THIS REPORT IS A FIELD STRUCTURAL SITE ANALYSIS OF THE EXISTING CONDITIONS OF THE NORTH ELEVATION UNDERLYING WYTHES OF MASONRY AFTER THE STONE VENEER REMOVAL. SITE ANALYSIS ALSO INCLUDED THE EXTG. CONDITIONS OF THE 2 X 12 ROOF RAFTER ASSEMBLY & RECOMMENDATIONS FOR REMEDIATION.

FIELD STRUCTURAL SITE ANALYSIS EVALUATION REPORT

SUBJECT PROPERTY: 35 N. BROADWAY, AURORA IL. 60505

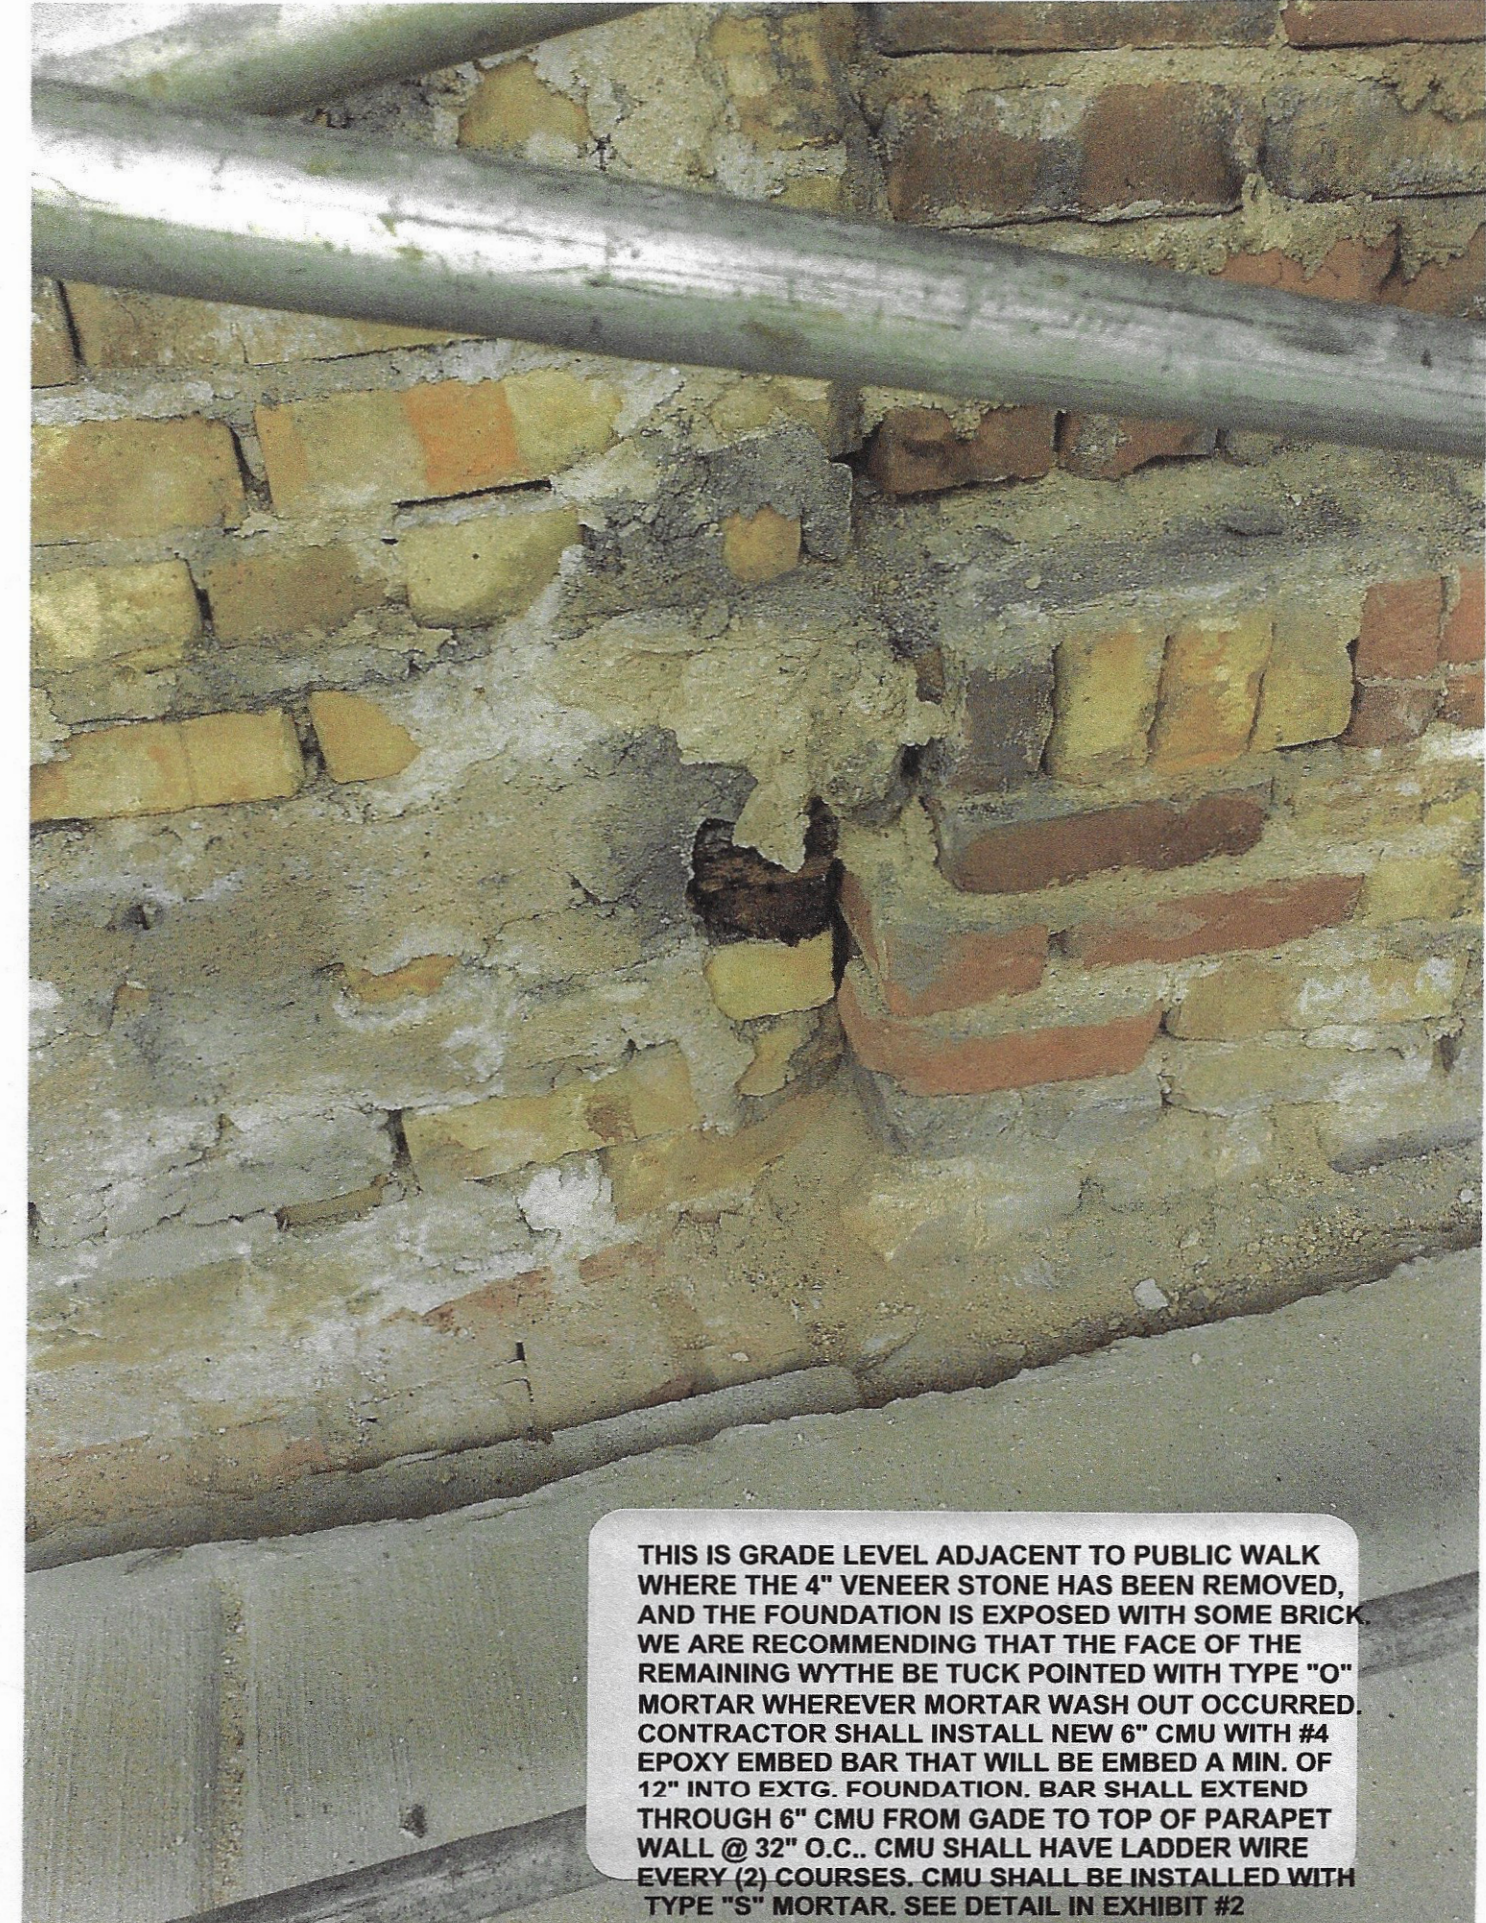
EXTG, DOUG FIR 2 X 12 JOISTS THAT HAVE WATER DETERIORATION DAMAGE ON THE FIRE CUT ENDS THAT BEAR INTO THE MASONRY. ALL 22'-0" JOISTS SHAL BE SISTERED WITH A NEW DOUG FIR SELECT 2 X 12 AND A SMALLER MEMBER SHALL ATTACHED TO THE OPPOSITE SIDE TO PROVIDE ADEQUATE BEARING INTO THE MASONRY WALL. SEE DETAIL IN EXHIBIT #2.

EXTG. CONDITIONS 2 X 4 CRIPPLE KNEE WALL THAT IS COMPRISED OF 2 X 4'S @ 16" O.C. THAT REST ATOP EXTG. 1 X 4 & 1 X 6. IN SOME INSTANCES THE 2 X 4 IS DIRECTLY CONNECTED TO THE ABOVE 2 X 12 RAFTER, AND IN OTHER SITUATIONS THE 2 X 4 STUD IS CONNECTED TO (1) 2 X 4 TOP PLATE. THIS CRIPPLE KNEE WALL IS NOT PROPERLY FRAMED AND IS NOT ADEQUATELY TRANSFERRING THE LIVE & DEAD LOADS. AT THE TIME OF INSPECTION, STUDS WERE TWISTED SOME RAFTERS & CEILING JOIST. SEE DETAILS IN EXHIBIT #2.

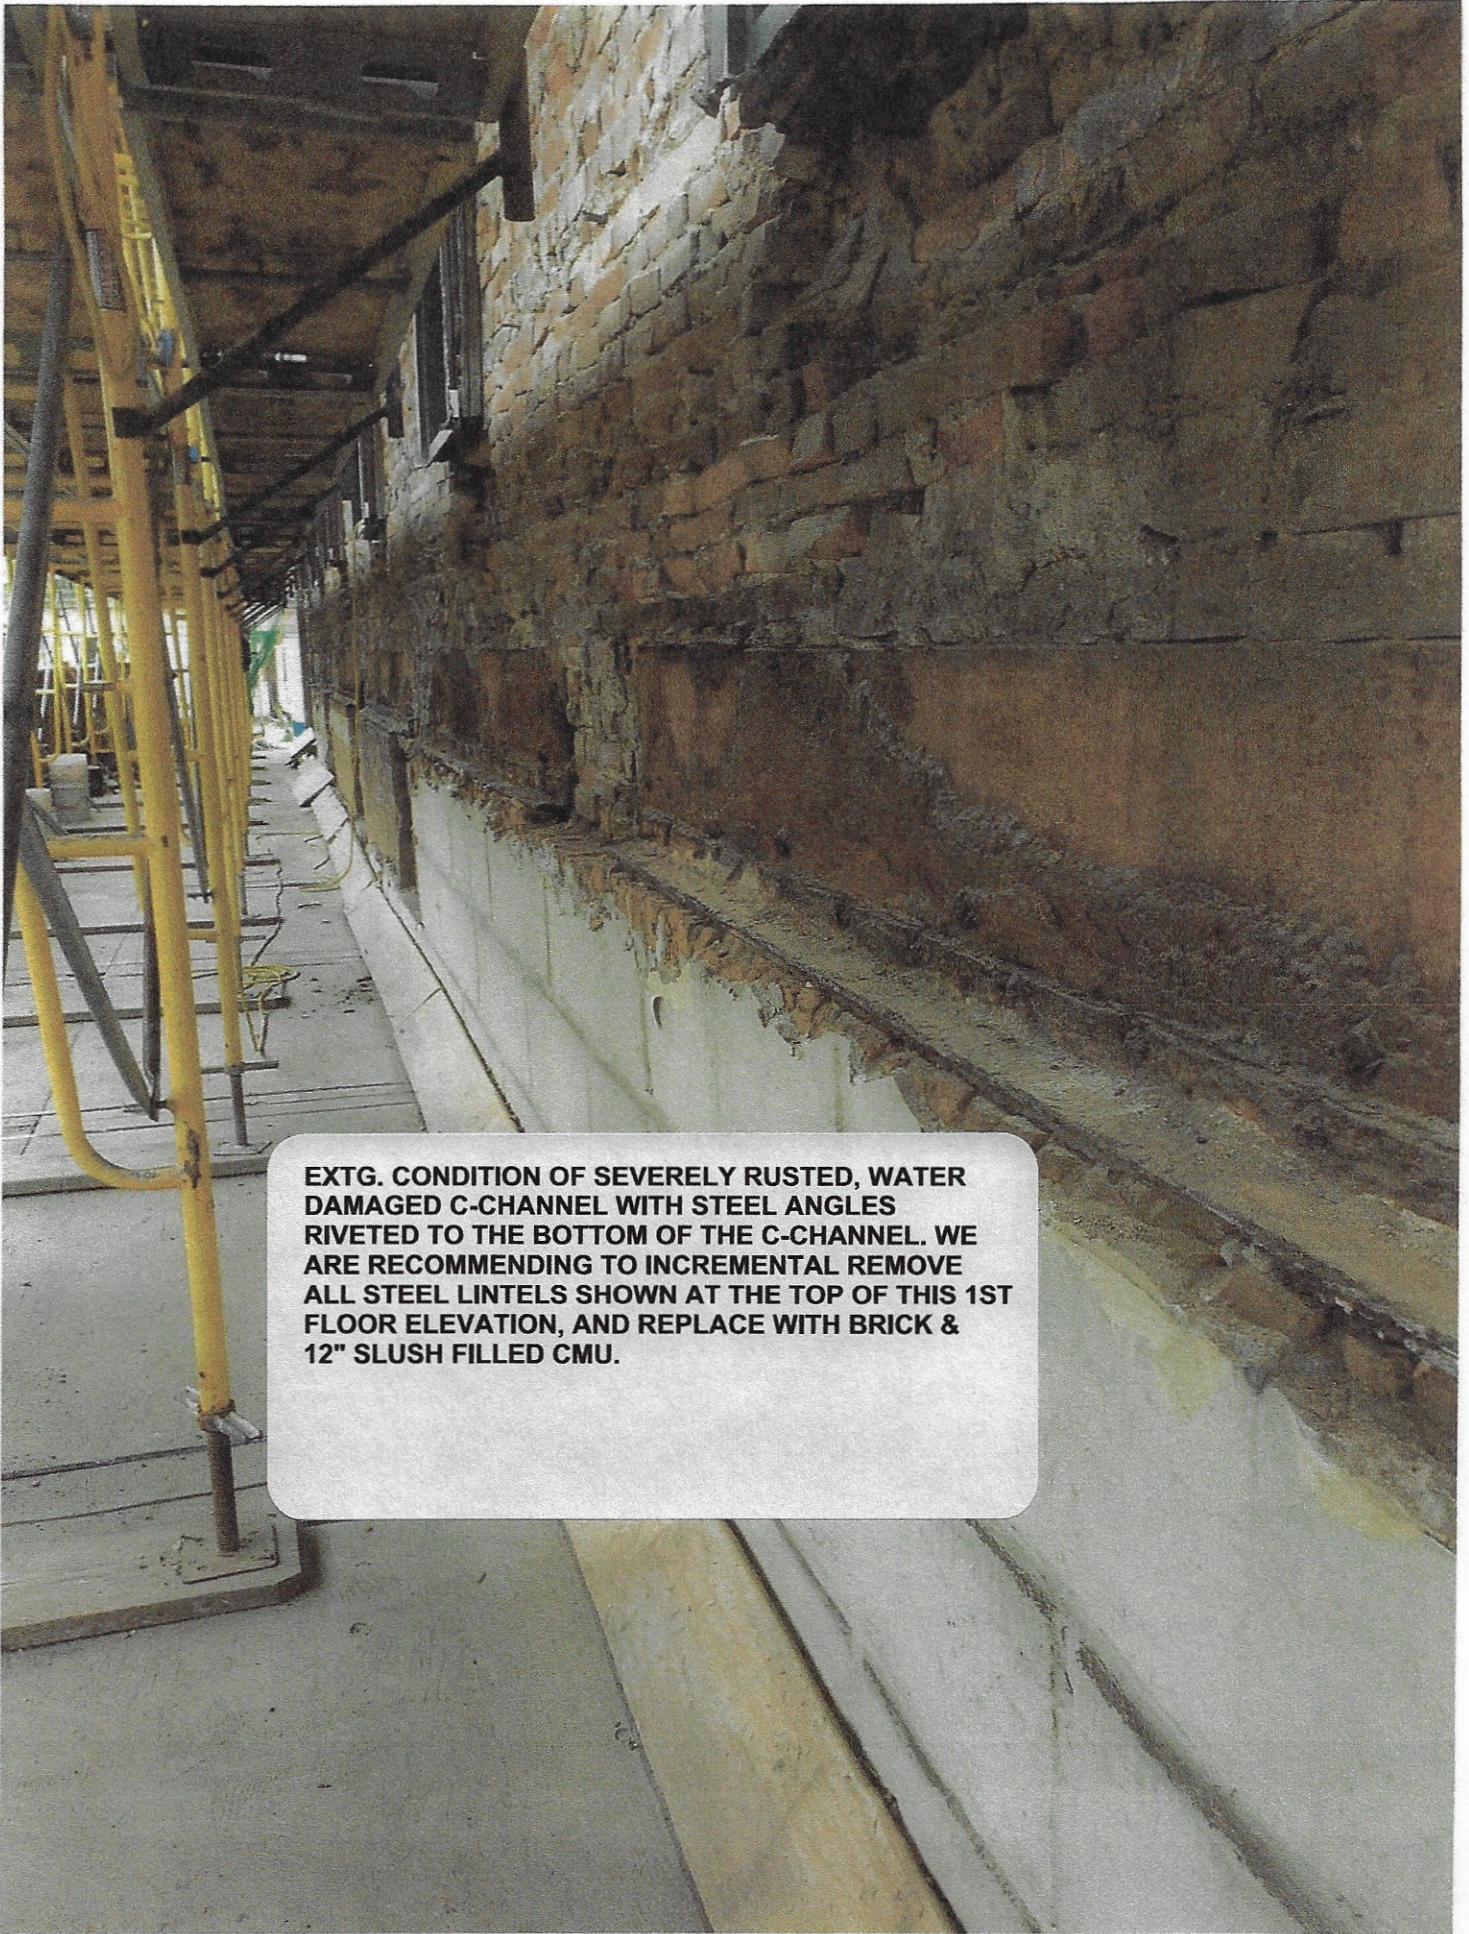
THIS IS GRADE LEVEL ADJACENT TO PUBLIC WALK WHERE THE 4" VENEER STONE HAS BEEN REMOVED, AND THE FOUNDATION IS EXPOSED WITH SOME BRICK. WE ARE RECOMMENDING THAT THE FACE OF THE REMAINING WYTHE BE TUCK POINTED WITH TYPE "O" MORTAR WHEREVER MORTAR WASH OUT OCCURRED. CONTRACTOR SHALL INSTALL NEW 6" CMU WITH #4 EPOXY EMBED BAR THAT WILL BE EMBED A MIN. OF 12" INTO EXTG. FOUNDATION. BAR SHALL EXTEND THROUGH 6" CMU FROM GADE TO TOP OF PARAPET WALL @ 32" O.C.. CMU SHALL HAVE LADDER WIRE EVERY (2) COURSES. CMU SHALL BE INSTALLED WITH TYPE "S" MORTAR. SEE DETAIL IN EXHIBIT #2

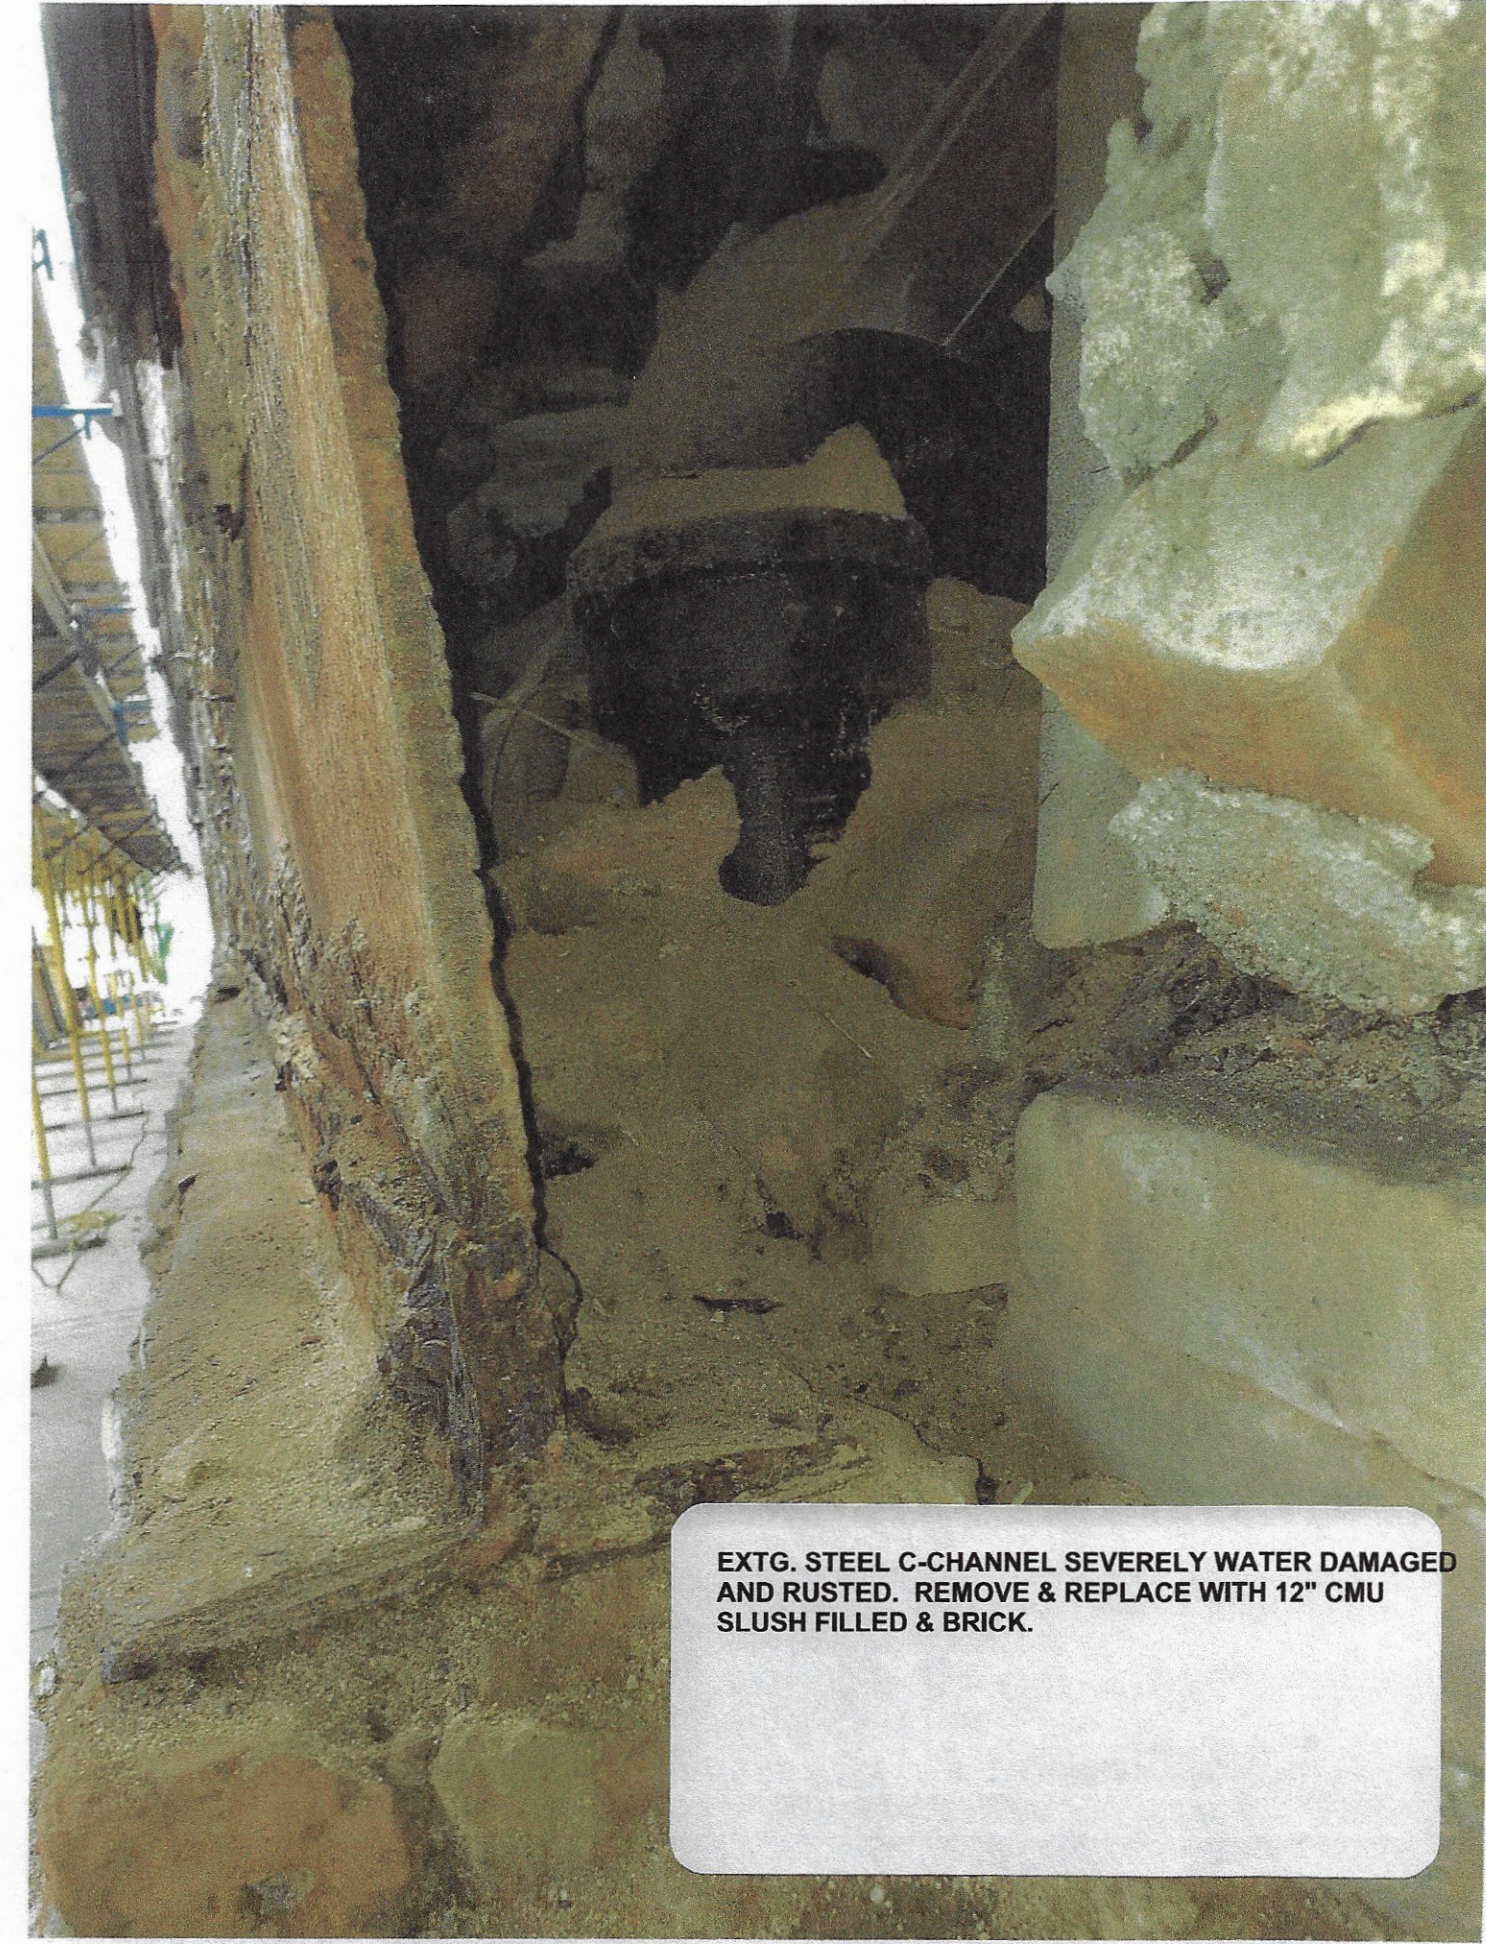
THIS IS THE AREA OF N.E. CORNER WHERE AN ADDITION WAS ADDED TO THE REAR OF THE BUILDING IN THE PAST. THE BIODEGRADABLE WOOD INSERTS SHOULD BE REMOVED & REPLACED WITH BRICK. CONTRACTOR SHALL INSTALL CONTROL JOINT FROM GRADE TO PARAPET WALL. ALL MORTAR WASH OUT SHALL BE TUCK POINTED WITH TYPE "O" MORTAR PER STANDARDS OF THE BRICK INDUSTRY ASSOCIATION & INTERNATIONAL BUILDING CODE.
